Product Change Notice (PCN)

PCN Number: PCN-0450036R-01

Product(s) Affected: MD-S series (part numbers MD-40S, MD-60S, MD-70S, MD-80S, MD-90S).

Description of Change: minor dimensional changes, such as pin length, and materials changes, as shown below.

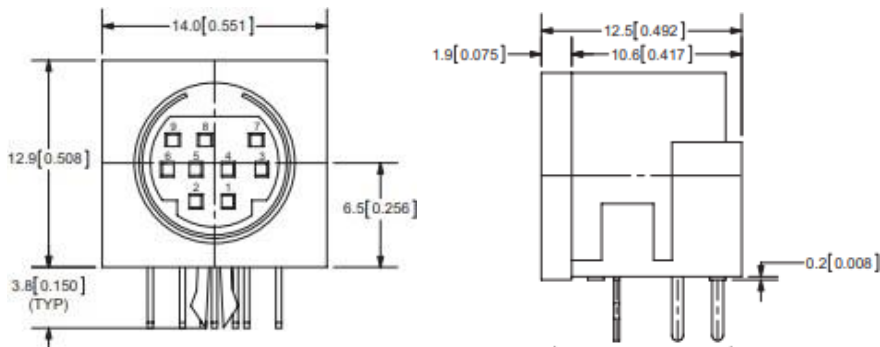
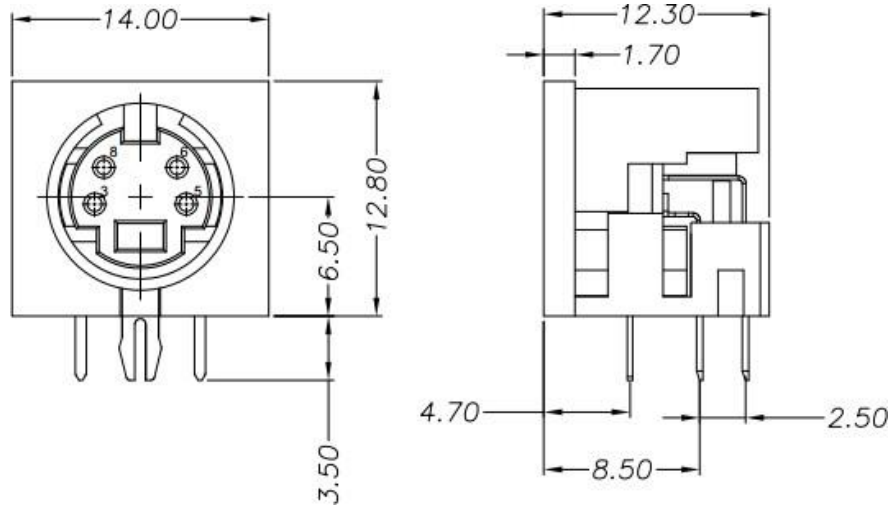
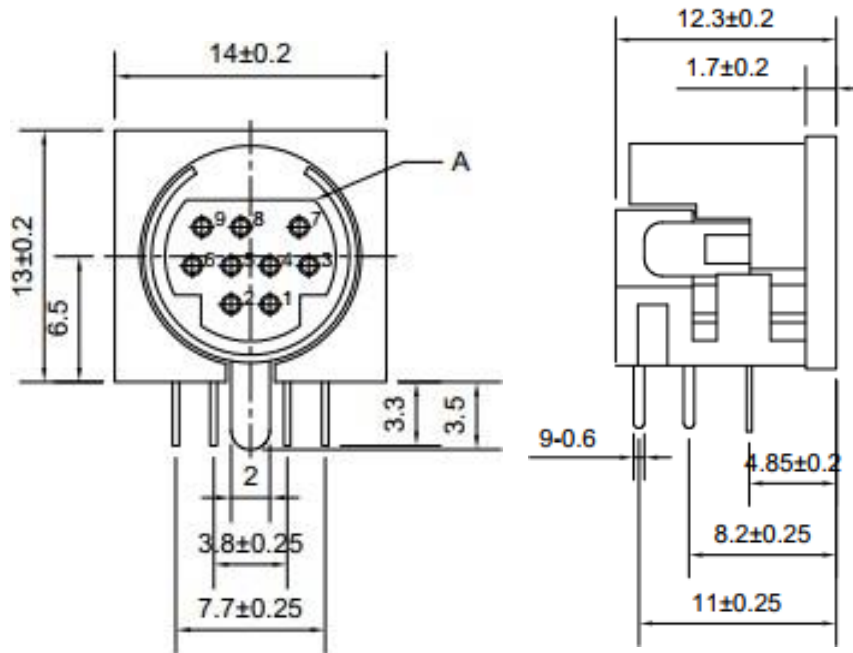
Reason(s) for Change: Manufacturing build location change.

Old Design (MD-40S, MD-60S, MD-70S, MD-80S)

Old Design (MD-90S)

New Design (MD-40S, MD-60S, MD-70S, MD-80S)

New Design (MD-90S)

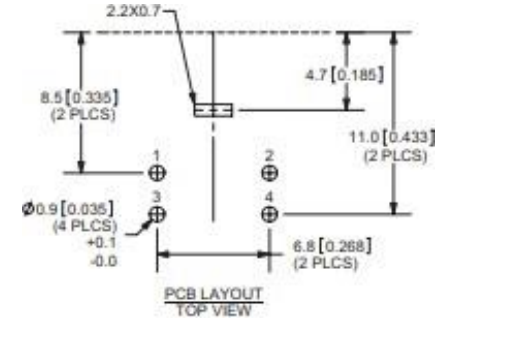
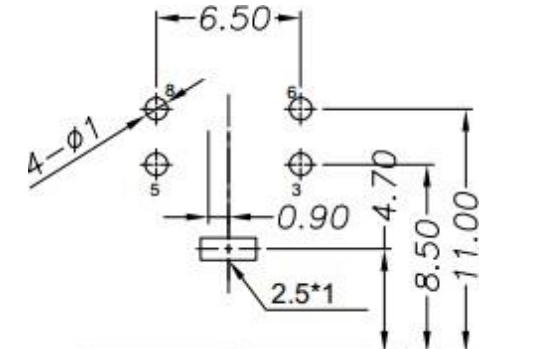
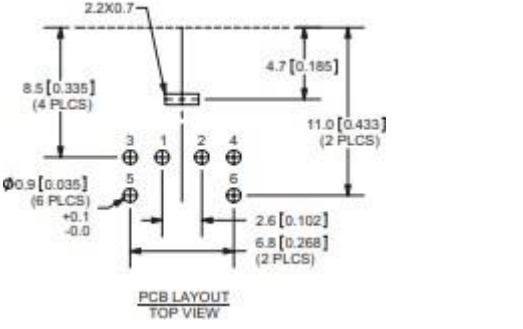
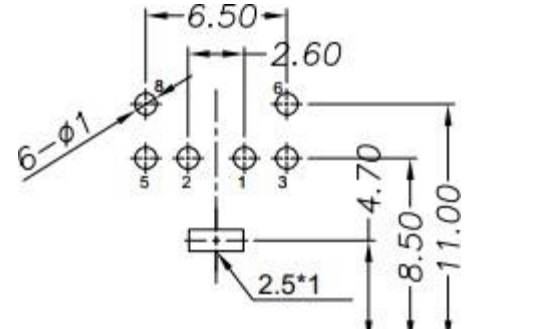
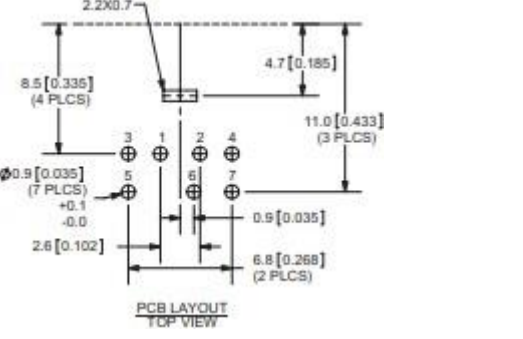
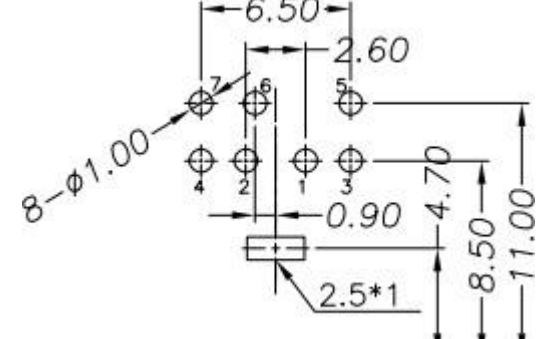
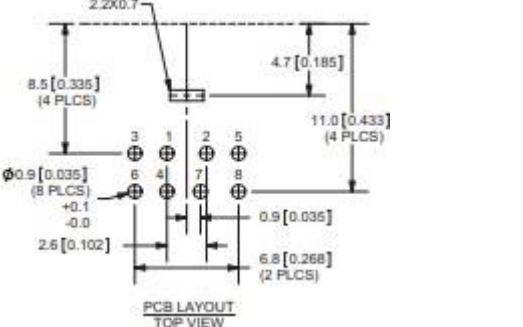
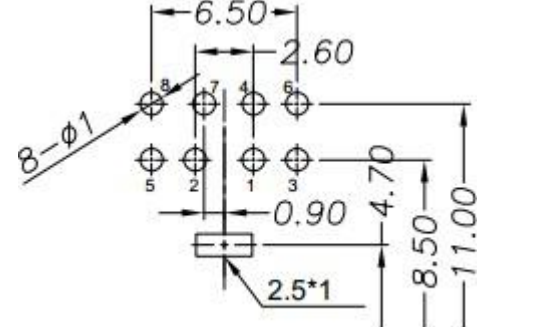
PCB Layout Old Design	PCB Layout New Design
 <p>PCB LAYOUT TOP VIEW</p> <p>Dimensions: 2.2x0.7, 8.5 [0.335] (2 PLCS), 4.7 [0.185], 11.0 [0.433] (2 PLCS), 6.8 [0.268] (2 PLCS), 0.9 [0.035] (4 PLCS) +0.1 -0.0</p>	 <p>Dimensions: 6.50, 4-φ1, 0.90, 4.70, 8.50, 11.00, 2.5*1</p>
 <p>PCB LAYOUT TOP VIEW</p> <p>Dimensions: 2.2x0.7, 8.5 [0.335] (4 PLCS), 4.7 [0.185], 11.0 [0.433] (2 PLCS), 5.8 [0.268] (2 PLCS), 2.6 [0.102], 0.9 [0.035] (6 PLCS) +0.1 -0.0</p>	 <p>Dimensions: 6.50, 6-φ1, 2.60, 4.70, 8.50, 11.00, 2.5*1</p>
 <p>PCB LAYOUT TDF VIEW</p> <p>Dimensions: 2.2x0.7, 8.5 [0.335] (4 PLCS), 4.7 [0.185], 11.0 [0.433] (3 PLCS), 6.8 [0.268] (2 PLCS), 0.9 [0.035], 2.6 [0.102], 0.9 [0.035] (7 PLCS) +0.1 -0.0</p>	 <p>Dimensions: 6.50, 8-φ1.00, 2.60, 4.70, 8.50, 11.00, 2.5*1, 0.90</p>
 <p>PCB LAYOUT TOP VIEW</p> <p>Dimensions: 2.2x0.7, 8.5 [0.335] (4 PLCS), 4.7 [0.185], 11.0 [0.433] (4 PLCS), 6.8 [0.268] (2 PLCS), 0.9 [0.035], 2.6 [0.102], 0.9 [0.035] (8 PLCS) +0.1 -0.0</p>	 <p>Dimensions: 6.50, 8-φ1, 2.60, 4.70, 8.50, 11.00, 2.5*1, 0.90</p>

Old Design Materials

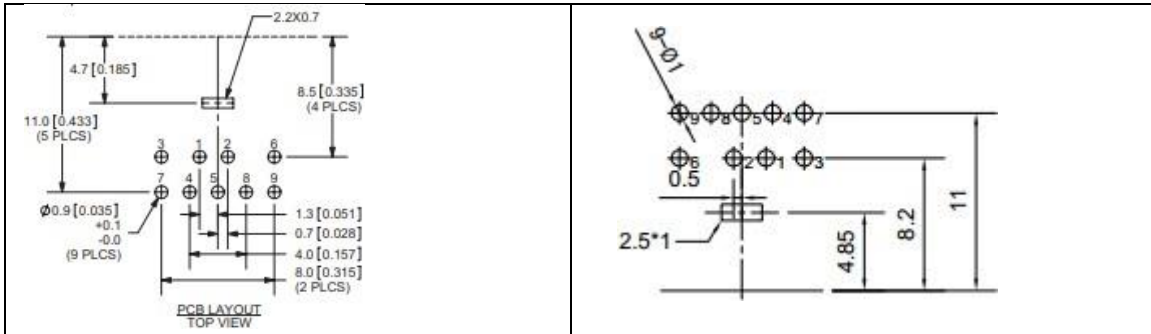
MATERIAL	PLATING
earth terminal	brass	tin
contact terminals (1~8)	phosphor bronze	silver
housing	PBT

MATERIAL	PLATING
body	PBT+30%GF (UL94V-0)	
pins	brass	tin
shield	brass	nickel
